HOZELOCK SPRAYERS

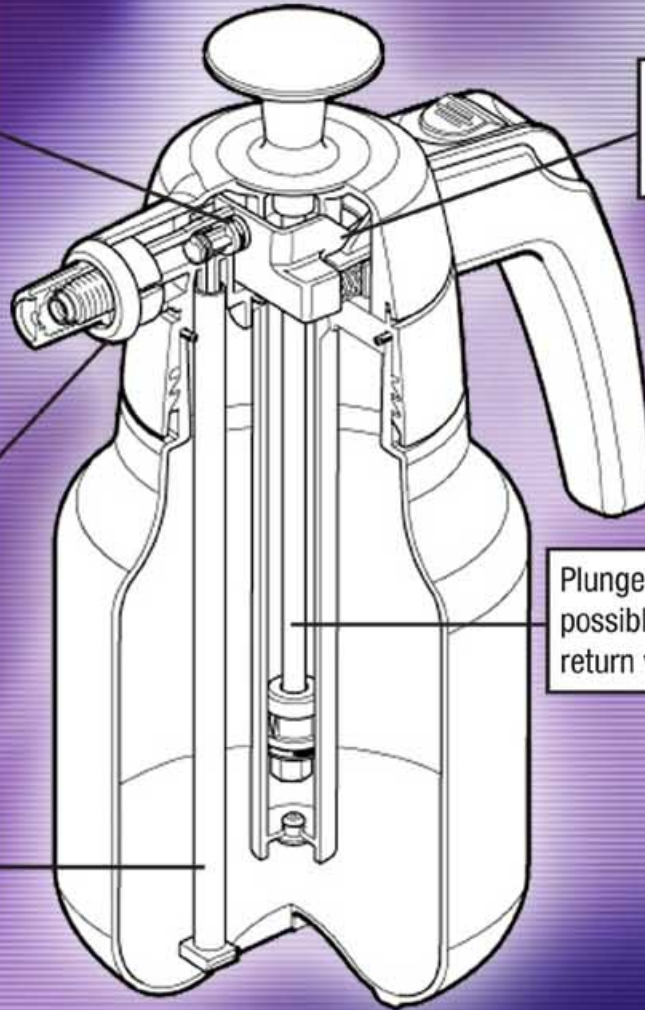
'o' rings in the shuttle assembly have been converted to viton seals for greater chemical resistance. All other seals remain nitrile.

Nozzle and 'o' ring shoulder increased to eliminate discharge from rear of nozzle.

Dip tube shortened to fit flush with the base of the container.

Modified cover and locking mechanism to improve lock-on facility at all pressures.

Plunger rod shortened to avoid possible contact with non-return valve.
